ADDENDUM 4 – JOB 3

ADDENDUM NO. 4

Project No. SU-8-992(040)041 PCN: 21569
Sheyenne Street Improvements – 40th Avenue to 32nd Avenue
West Fargo, ND

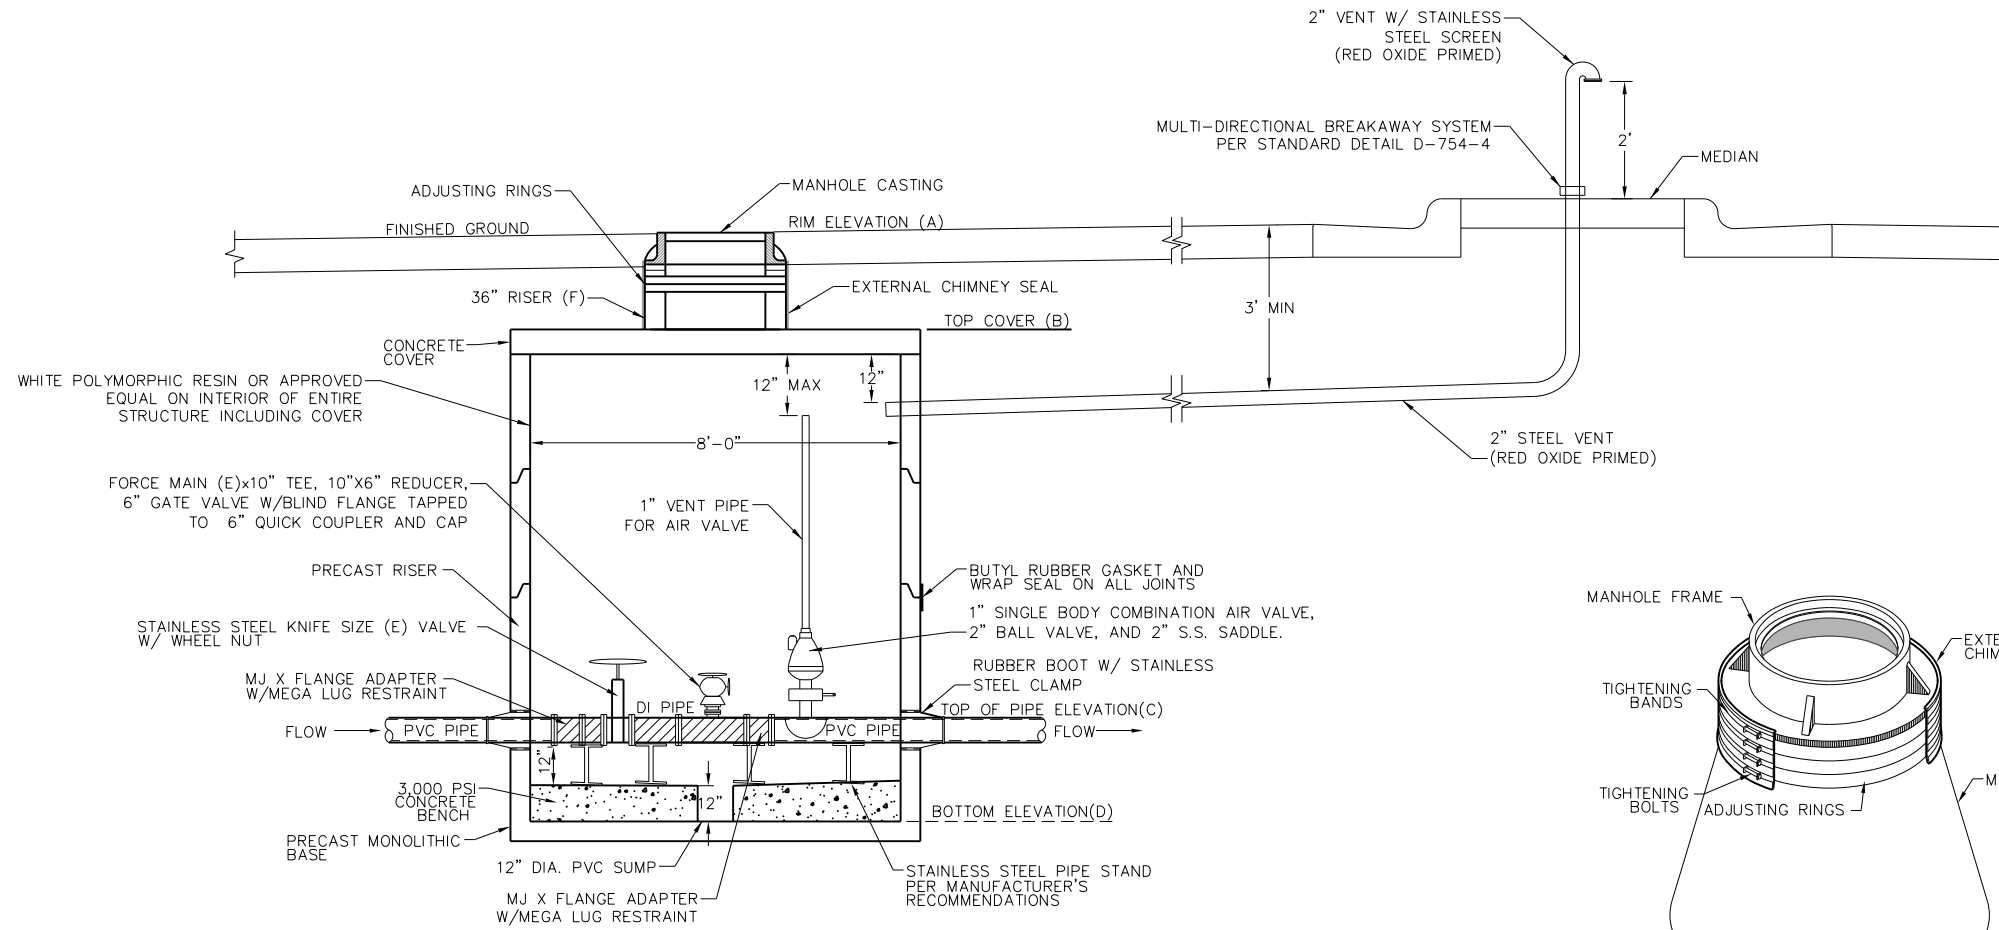
- Revised Limited Access Note 100-P04.

MAINTENANCE MANHOLE
NO SCALE

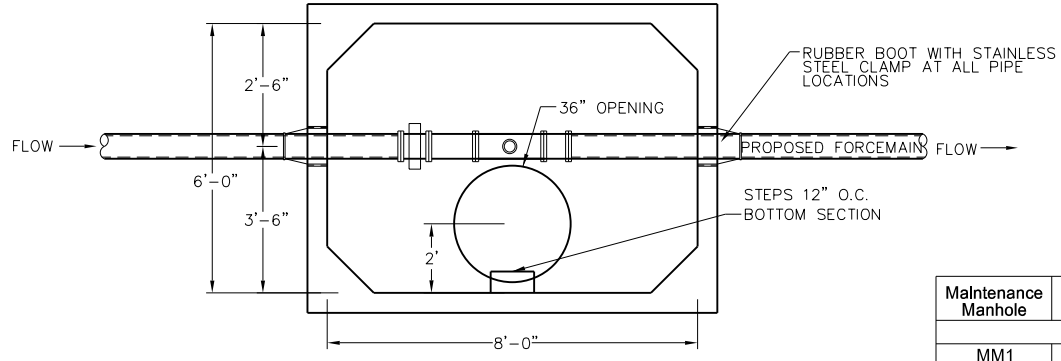
- Revise Maintenance Manhole Detail to add Manhole Casting type information, revise riser information, add size to air valve, callout 2" ball valve and 2" stainless steel saddle. In profile section, revise note 2 to remove the word "future" and add note 3. Revise Manhole Maintenance Elevation Chart information.

- NOTES:
- SUMP TO BE LOCATED DIRECTLY BELOW HATCH FOR PUMPING.
 - FORCEMAIN PIPE BETWEEN KNIFE VALVE AND AIR VALVE TO BE DUCTILE IRON CLASS 53. ALL OTHER FORCEMAIN PIPE TO BE C900.
 - MANHOLE CASTING TO HAVE GASKETS AND "SANITARY SEWER" LETTERING BY EAST JORDAN (1480AGS COVER WITH V1419 FRAME), NEENAH (R-1558), OR APPROVED EQUAL.
